INITIAL FIRE SAFETY INSPECTION REPORT

Absolute Qualitywear Ltd.

RSC ID: 24521

Date: 18 December, 2022

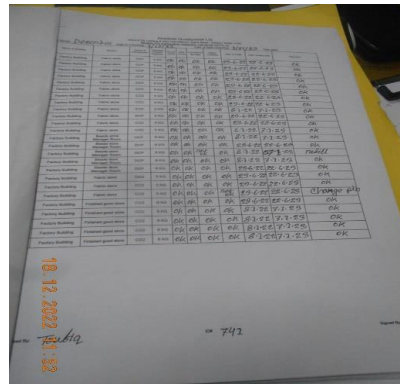
SI No.	Category	Findings	Required Action	Remediation Time Frame
F-1	Fire Rated Construction	Rooms used for storage of combustible materials located at several floors are not separated from the surrounding occupancy/areas. Location: Building 1 (Production)	Rooms used for storage of combustible materials shall be separated from the surrounding occupancy with a minimum 1 hour construction.	Within 3 months

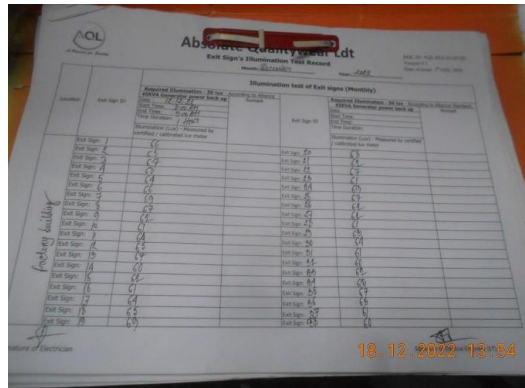
F-8	Egress Lighting	Manual on-off switch is provided for [emergency lighting / exit signage] units. Location: Building-1 (Production) & Building-2 (Office)	Remove manual on/off switches from emergency lighting / exit signage units to prevent them from being switched off.	Within 1 month
-----	-----------------	---	---	----------------
